Tech Notice for FlightPower 2S, 4S, & 6S Battery Packs

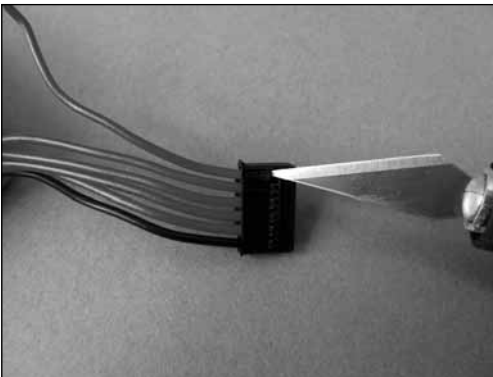
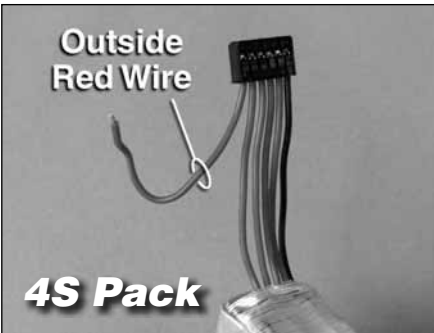
The indicated red wire leads on these three packs, may come detached from the battery. While these wires are attached to the balance connector, they are **not connected** to the battery circuitry. The battery will charge and discharge properly without these wires attached to the battery or the balance lead.

It is recommended that you remove these wires from the balance connector. This can be done by using a hobby knife to pry the plastic retaining clip and removing the wire. This is only recommended for Flight Power 2S, 4S, and 6S packs.
